Service Bulletin

Bulletin No. 2012-09
OEM No. 2012-05

Alternator End Cover Contacting Cylinder Block—150 FourStroke Models Affected

Models Covered	Serial Number
150 FourStroke	1B906474–1B943665

51272

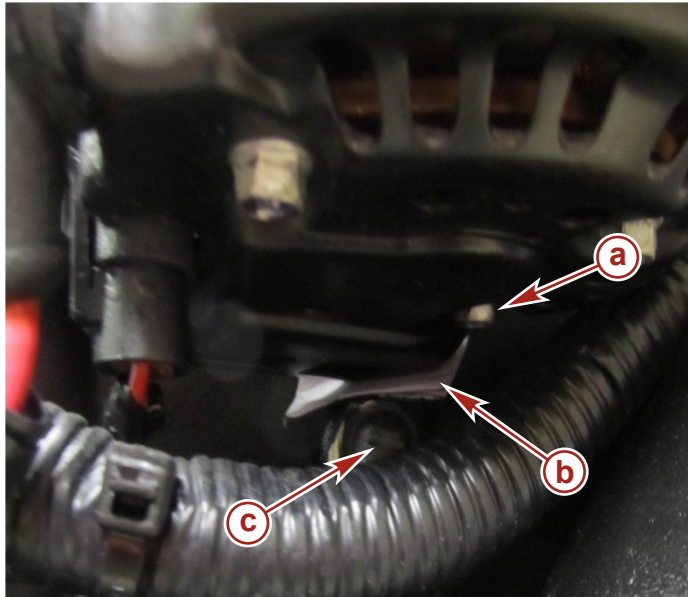
Mercury Marine has identified a possible interference issue between the alternator end cover and the cylinder block on the outboard listed above. If the contacting alternator is exposed to extended engine operation, induced vibration can cause alternator stator wire fractures, which will reduce the alternator output. Output will be reduced from 60 amps to 46 amps if one phase winding experiences a fracture. No alternator output will occur if all phase windings fracture, or if the common winding lead experiences a wire fracture. Mercury Marine has changed the design of the alternator end cover to assure clearance between the cover and the cylinder block. Affected outboards will need to be inspected and, if necessary, corrected following the procedures outlined in this service bulletin.

- Inspect for a 0.254 mm (0.010 in.) clearance between the innermost corner of the alternator end cover and the cylinder block just above the flush hose fitting boss.
IMPORTANT: Use a folded sheet of paper or a piece of cardboard stock which is flexible enough to bend around the flush fitting boss. A sheet of copy paper is approximately 0.1 mm (0.004 in.) so three thicknesses or a trifold piece would work as a gauge.

2. If the folded paper sheet or cardboard gauge can slide between the alternator end cover and the cylinder block, the clearance is sufficient and no corrective action is required.
3. If the gauge cannot slide between the alternator end cover and the cylinder block as described, proceed to the correction instructions.

51273

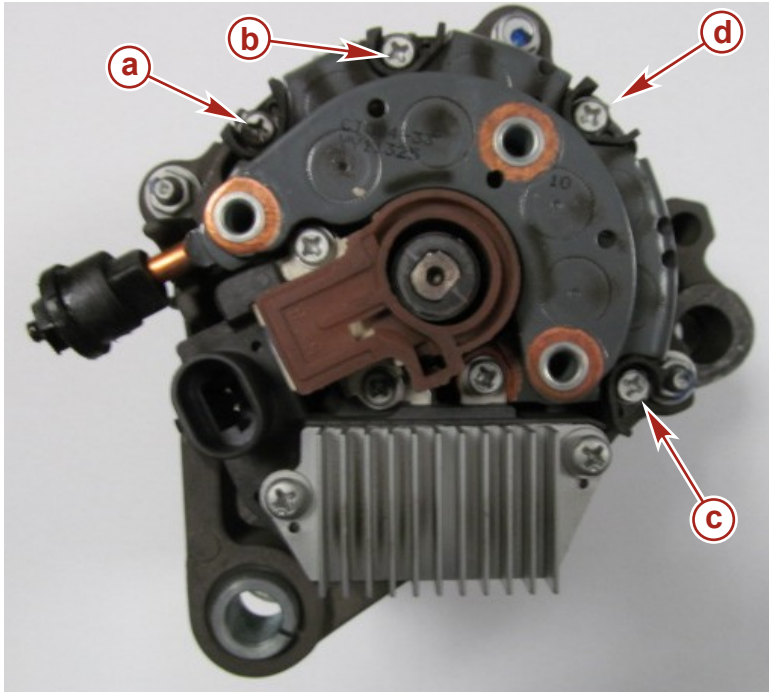
1. Remove and retain three screws securing end cover.
IMPORTANT: To avoid damaging the B+ terminal stud, use hand tools only to loosen the B+ terminal hex nut.
2. Loosen the nut on the B+ terminal to allow the insulator collar to be disengaged from the alternator end cover.
3. Remove the alternator end cover.
4. Using an ohmmeter verify that the alternator phase windings have the specified continuity.
5. Replace alternators which do not pass all of the continuity tests.

Meter Test Leads		Meter Scale	Readings (Ω)
Red	Black		
Terminal A	Terminal D	Auto	1.0 ohms or less
Terminal B	Terminal D	Auto	1.0 ohms or less
Terminal C	Terminal D	Auto	1.0 ohms or less

51274

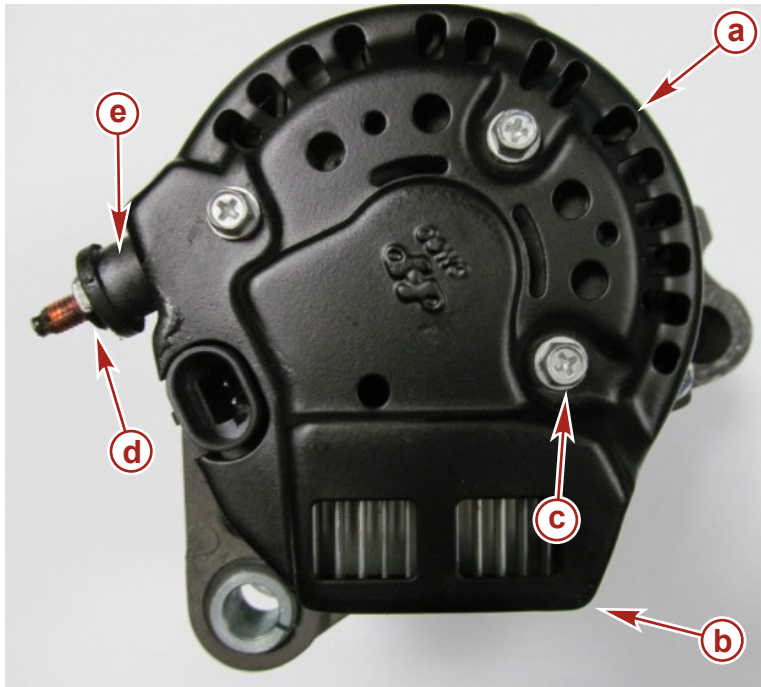
6. Install the new alternator end cover and secure it with the three retained screws. Tighten the retaining screws to the specified torque.
7. Engage the insulator collar into the alternator end cover and tighten the B+ hex nut to the specified torque.

Description	Nm	lb-in.	lb-ft
Alternator end cover screw (M4 x 25 mm)	4.5	40	–
B+ terminal nut (M6)	3.6	32	–

51275

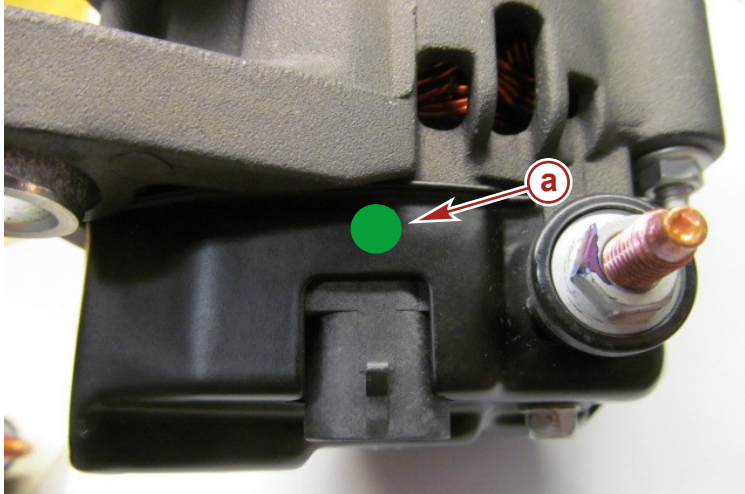
Packaged alternators (P/N 8M0057693) in dealer parts inventory should be inspected for the factory rework paint mark. If the paint mark is not present, the alternator end cover should be replaced and a green paint mark applied by the dealer.

Affected outboards that have been reworked at the factory are identified with a green paint mark located on the alternator end cover just above the 2-pin connector.

Dealers should also identify any inspected or reworked alternators with a green paint mark at the same location.
